90% CONSTRUCTION DOCUMENTS

**RWRF STORMWATER
IMPROVEMENTS
PREPARED FOR
WOODMEN HILLS
METROPOLITAN DISTRICT
EL PASO COUNTY
COLORADO**

V2_Construction Drawings (Plans-Profiles).pdf Markup Summary

SITE PLAN

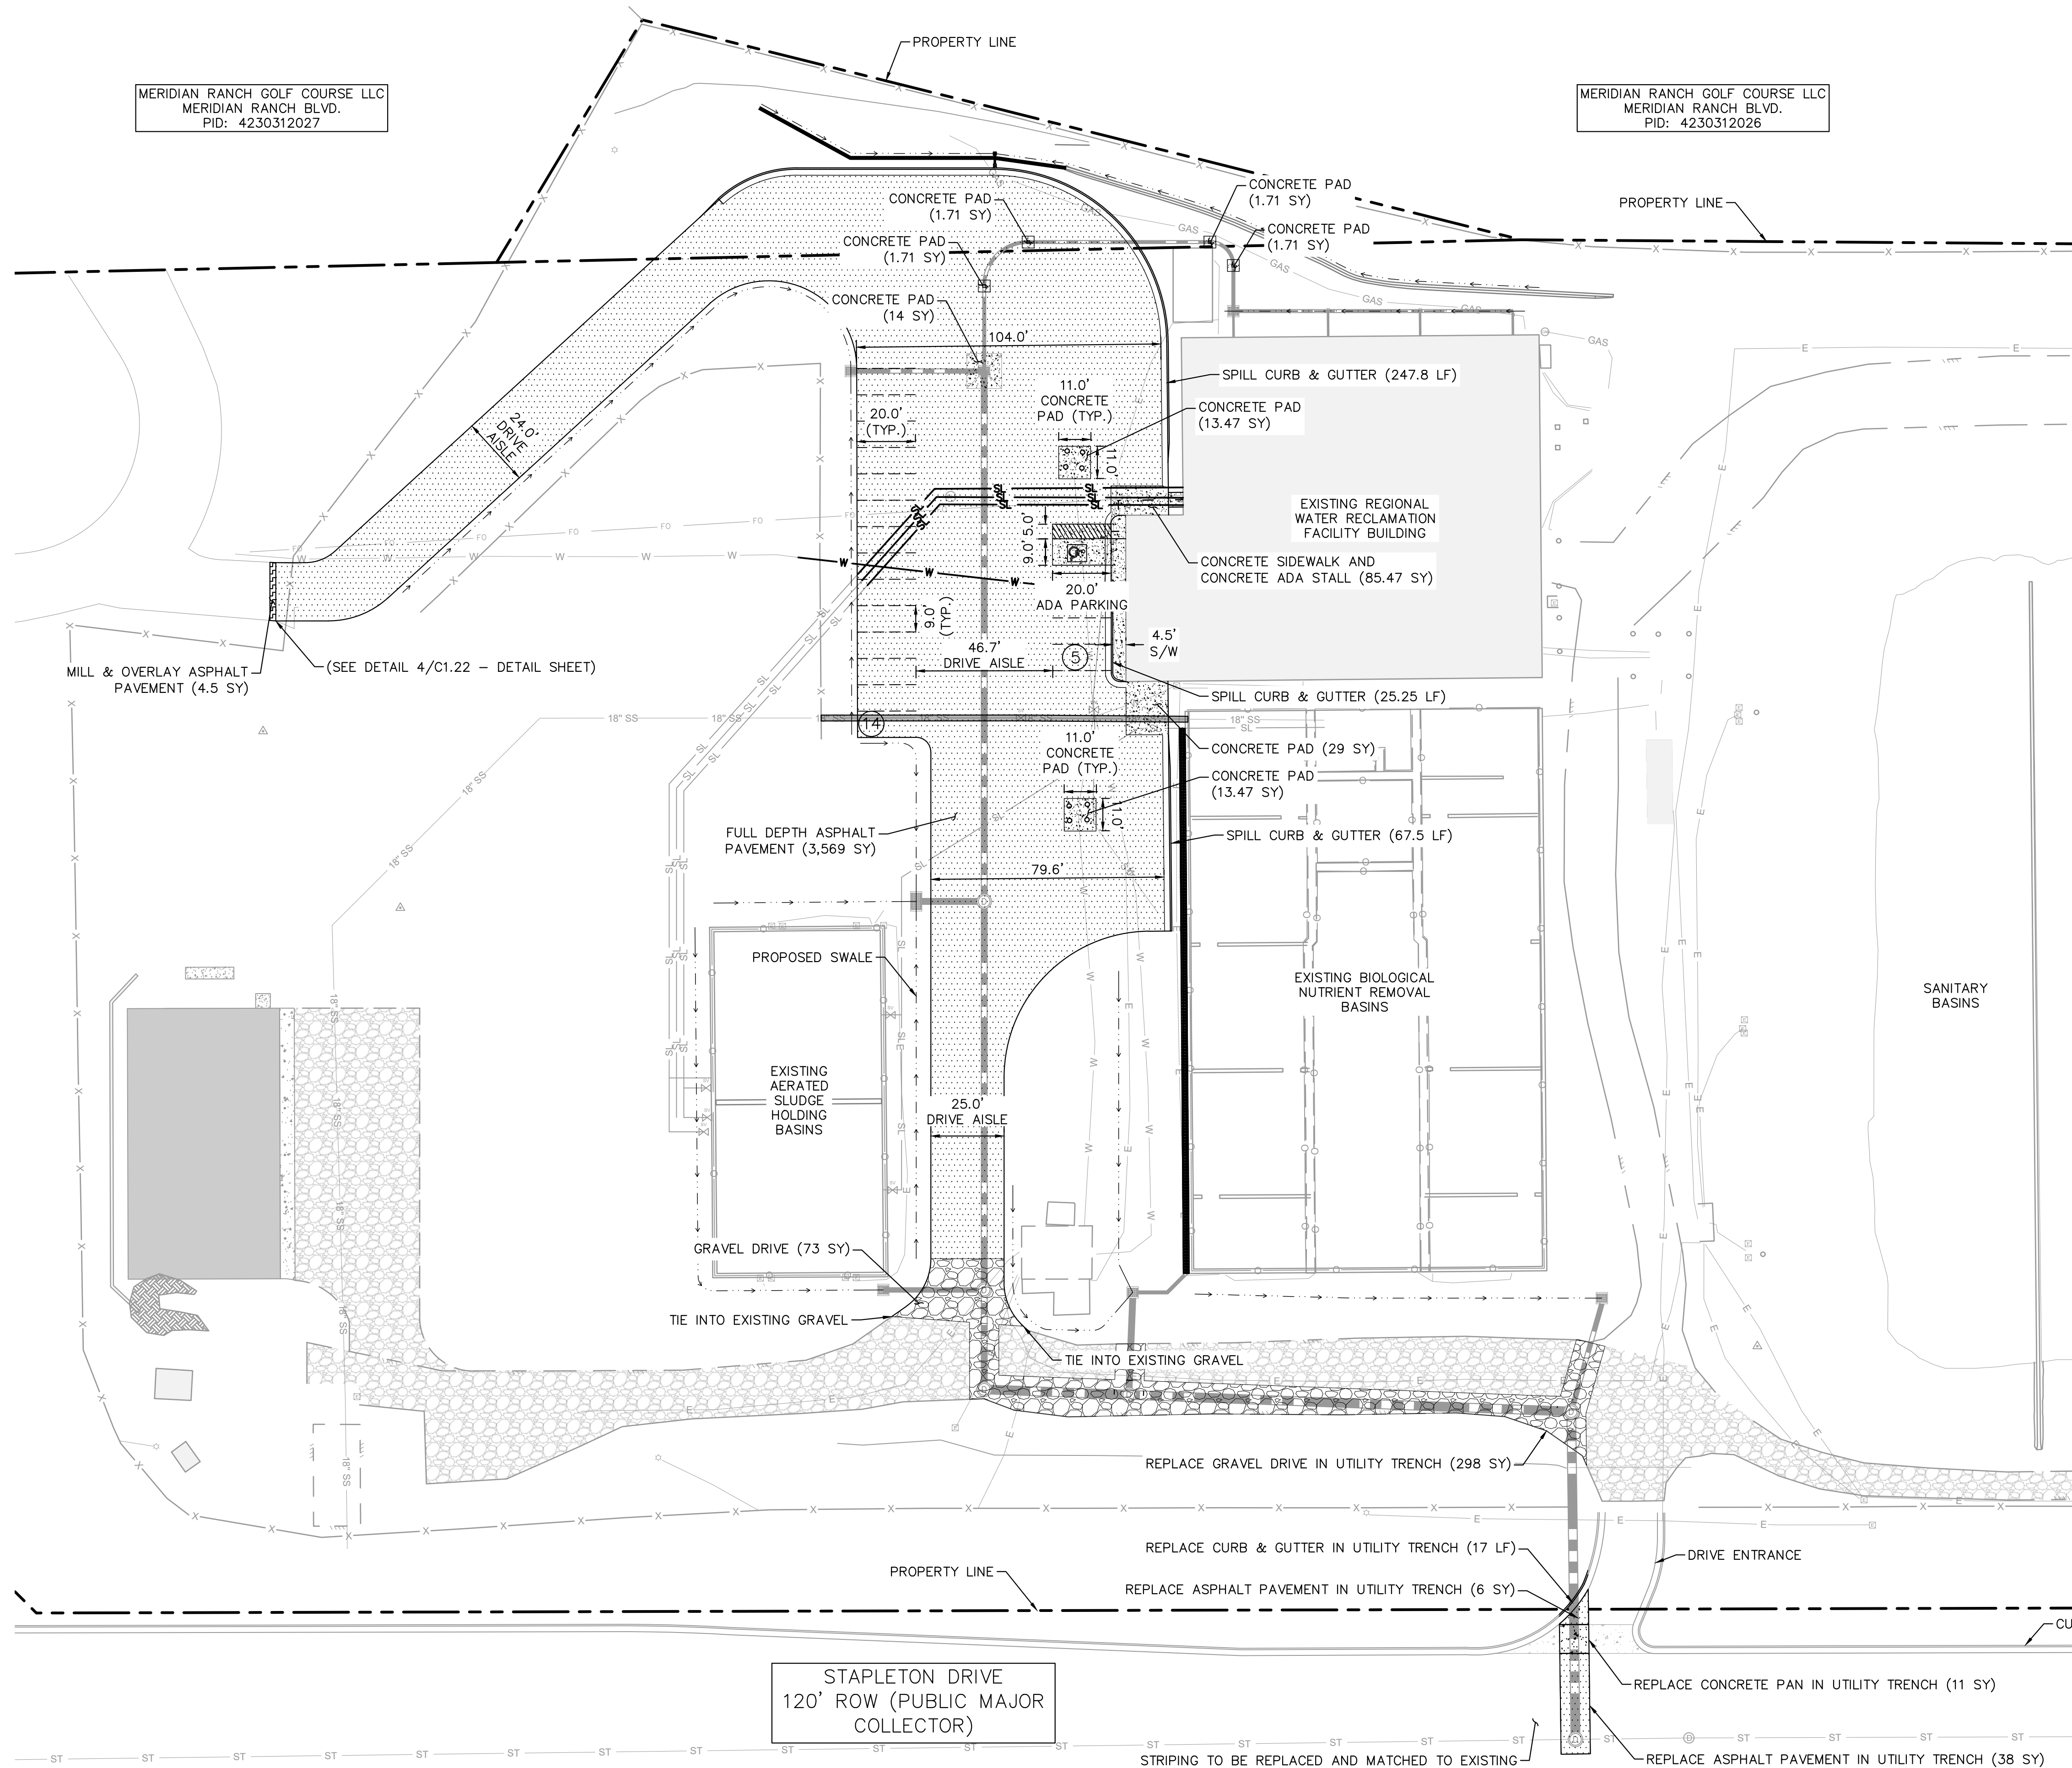
Informational Note:
Since the retaining wall exceeds 4', a building permit from PPRBD is required prior to construction.

STORM PLAN AND PROFILE

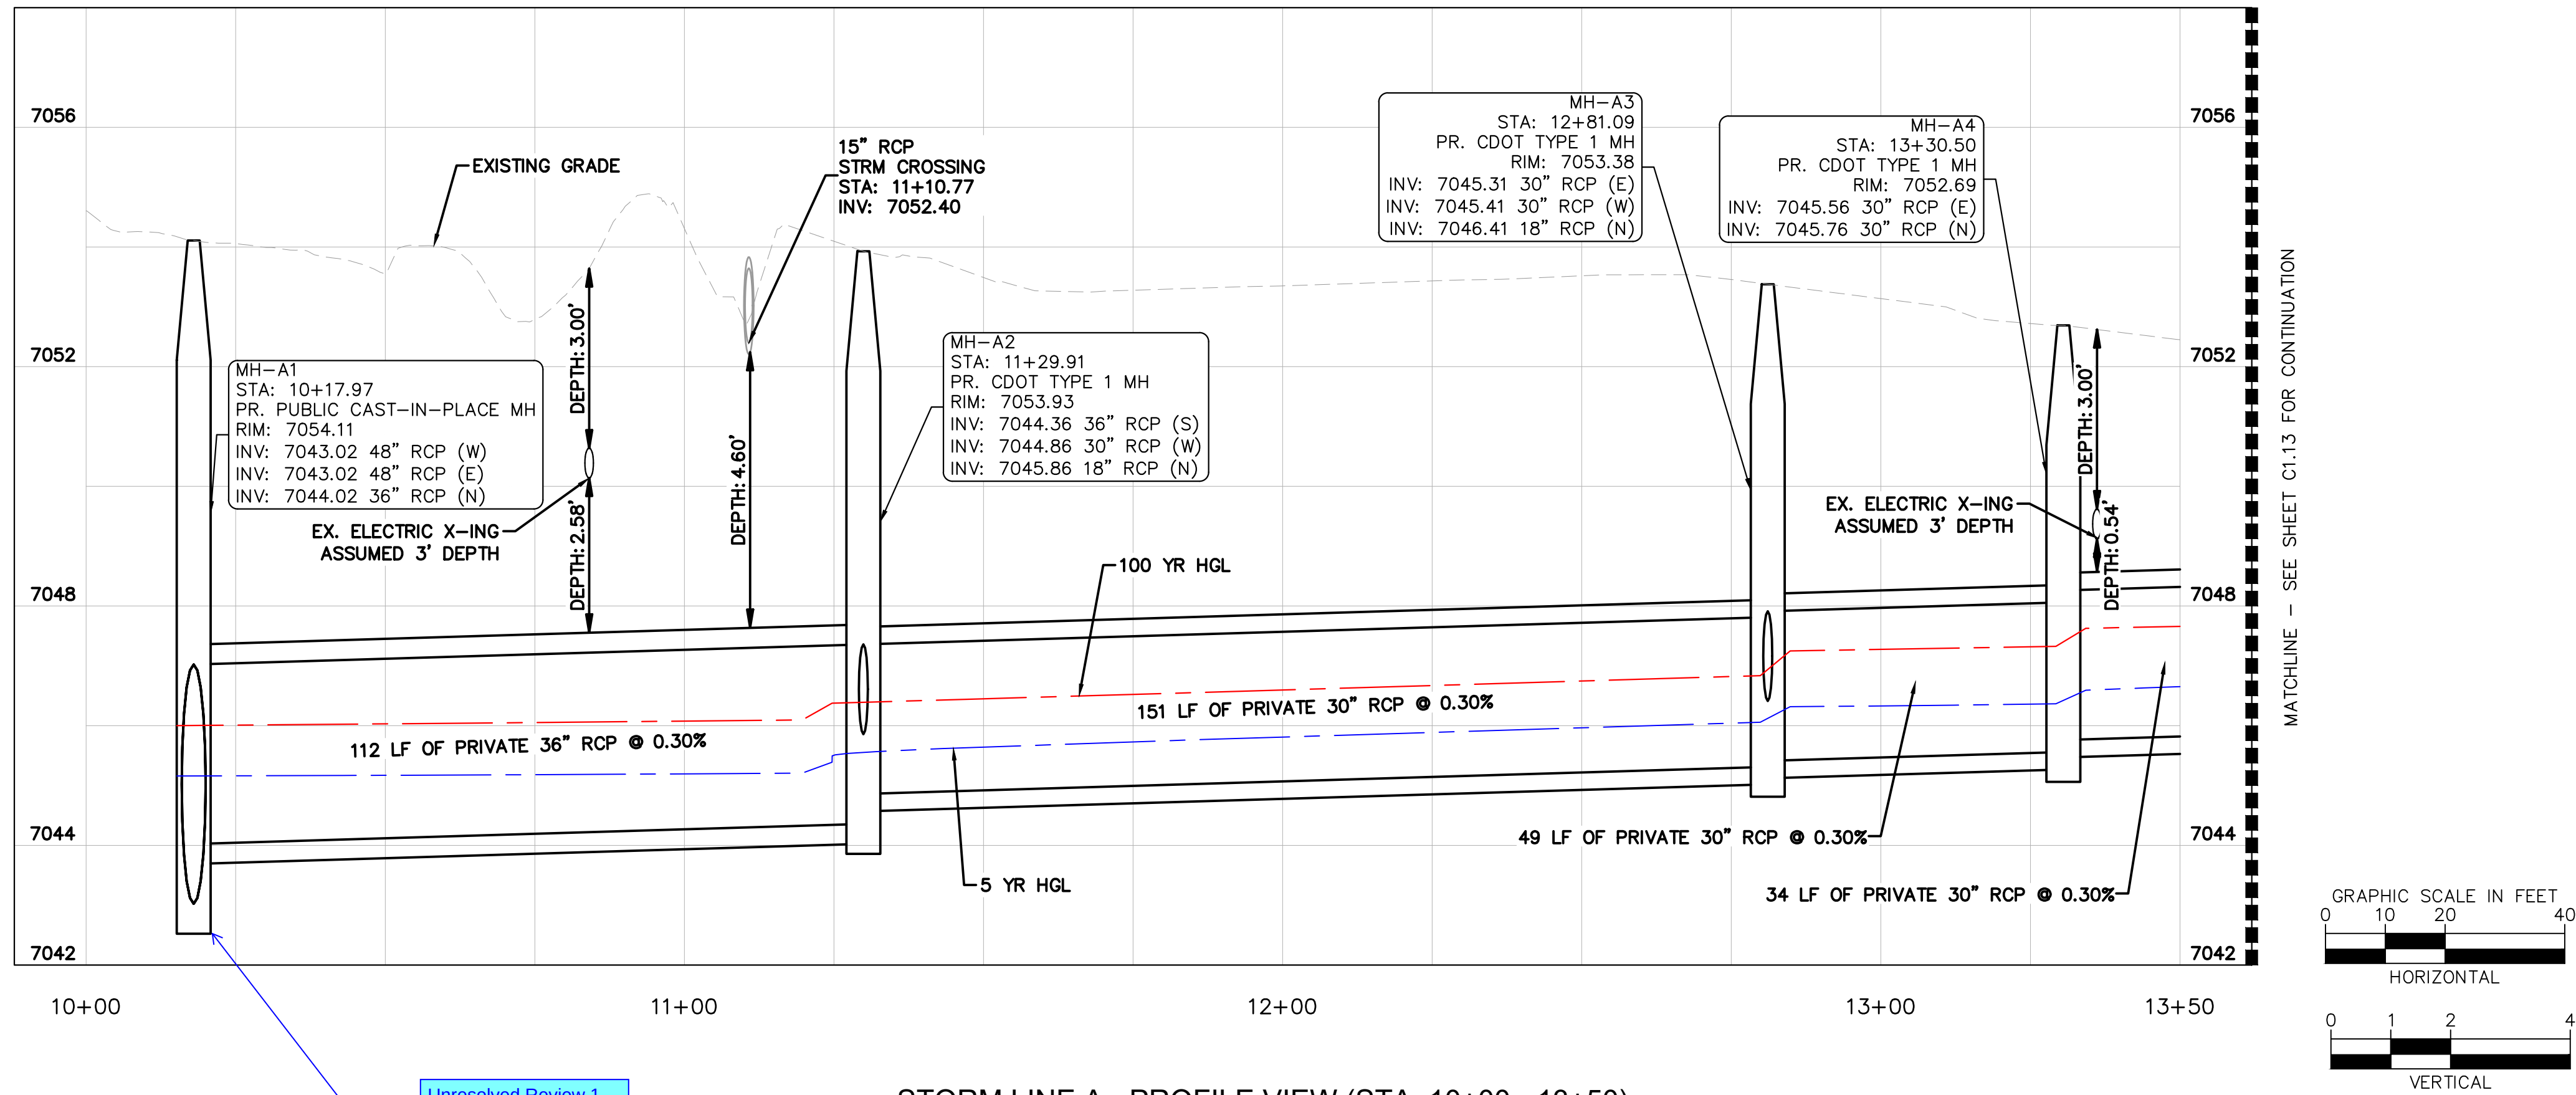
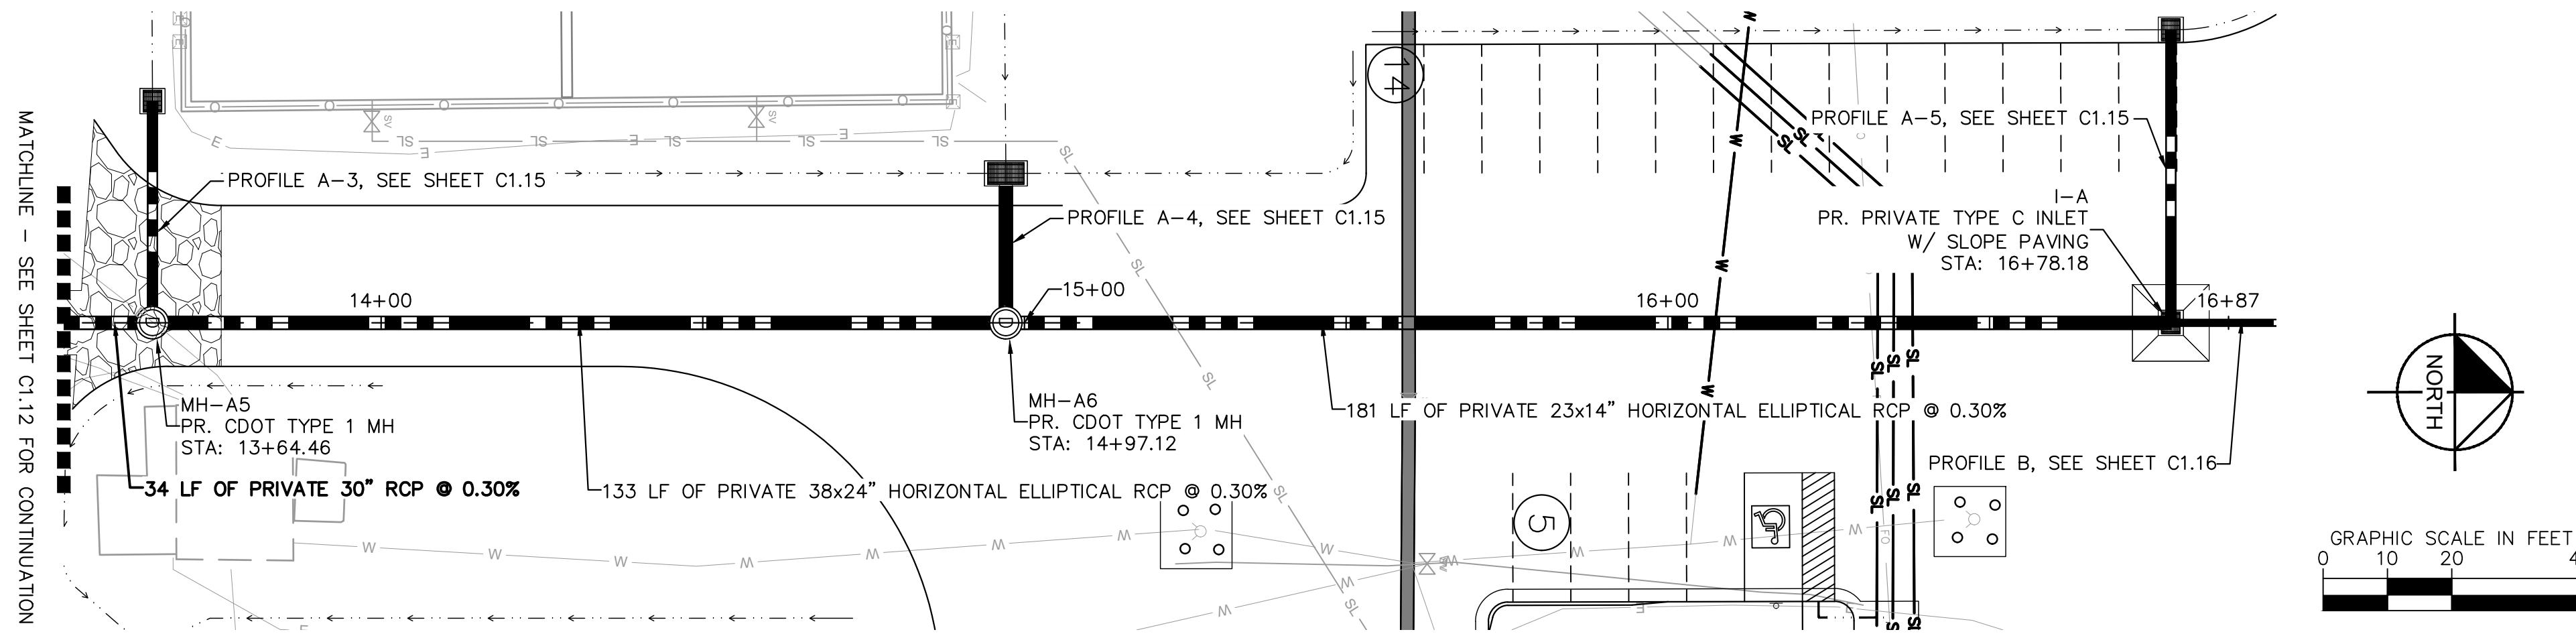
Unresolved Review 1 Comment:
Provide detail for the cast in place manhole specific to what is proposed here and has dimensions.

Unresolved Review 1 Comment:
Please submit a license agreement for the private pipe within the County ROW. License Agreement template:
<https://publicworks.elpasoco.com/departments-public-works/county-engineer/>
